03E-009 (1/11)

PART 573 Defect and Noncompliance Report¹

Generic name of the Item: Alternator Support Brace (Lower)

Generic name of the Item: Alternator Support Bracket (Upper)

(Attached is a schematic view of the engine showing the suspect parts.)

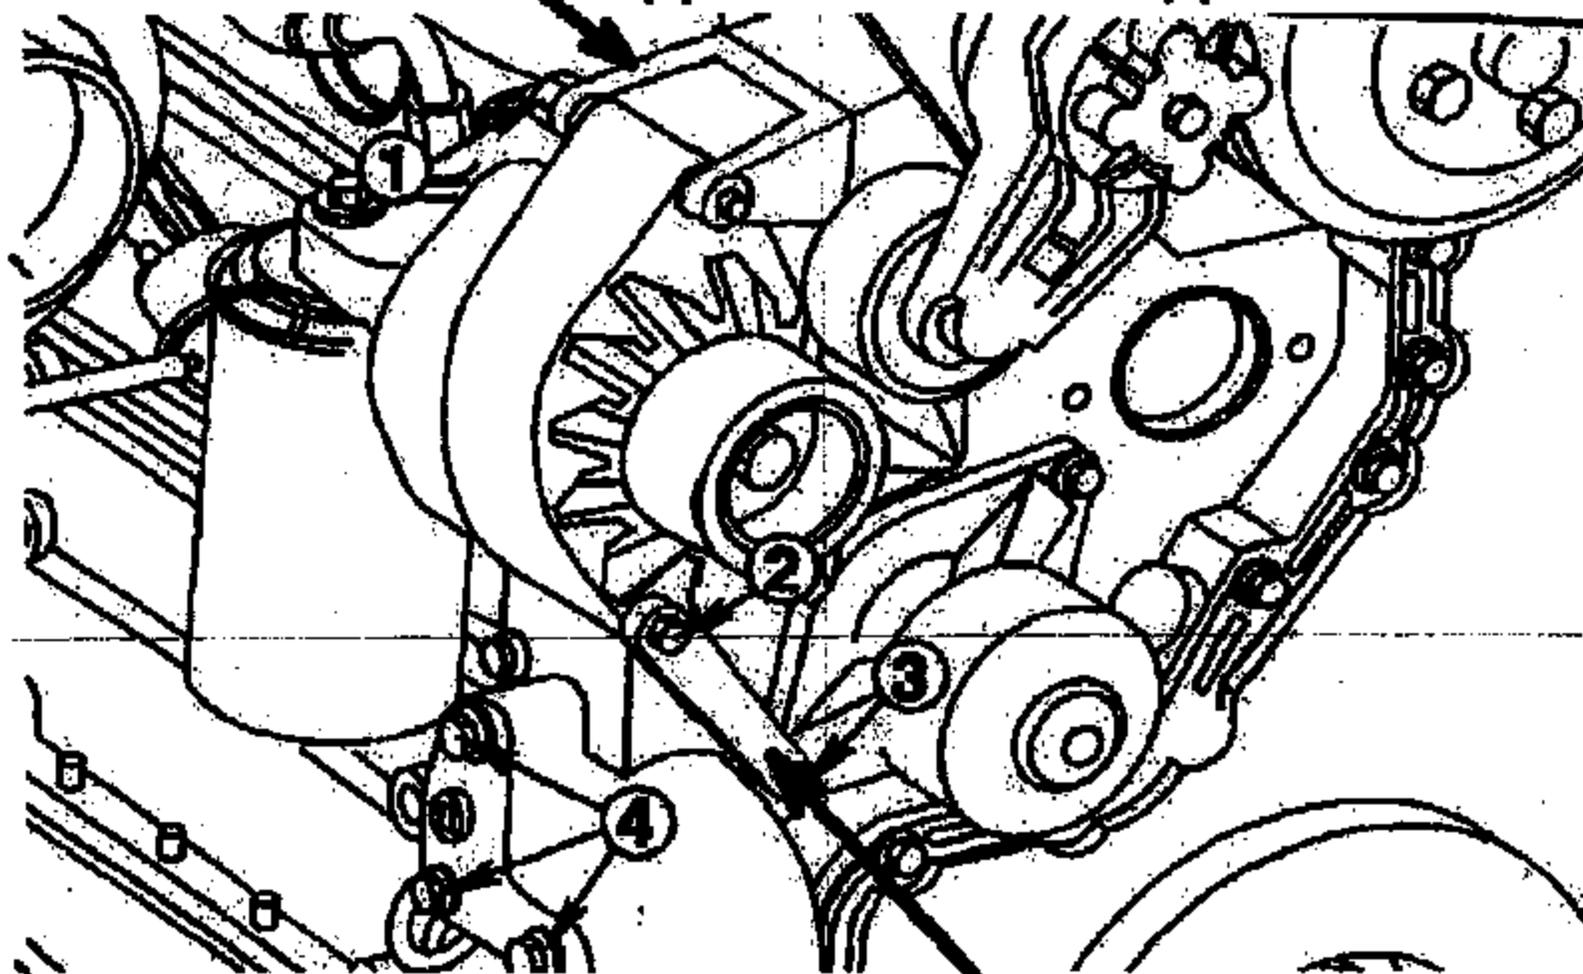
The combination of the old alternator bracket and alternator brace is not capable of holding some of the heavy alternators (>17 lbs.). In most of the failures this will lead to loosening of the mounting hardware (bolts) or breakage of the lower brace. This can release the alternator and let it fall. The damage will vary, depending on which side breaks first.

When used with alternators over 17lbs, the lower alternator support brace or mounting hardware may loosen or break possibly causing the upper alternator support bracket to also fall resulting in the alternator drooping to the engine. Under these conditions electrical wiring harness damage and the possibility of engine compartment fire may exist.

Upper alternator support bracket

Lower alternator support brace

The remedy for current and future production is to install the updated upper alternator support bracket on engines produced. In addition, Cummins is conducting a service campaign to replace the existing upper alternator support bracket with the new design and replace the existing lower alternator support brace and all mounting hardware on units where the OEM has installed an alternator weighing 17 or more pounds.

The remedy used in the service campaign is an updated upper alternator support bracket that has been redesigned to support alternators with a gross weight of 17 pounds or more. We have also established OEM instructions defining weight limitations.
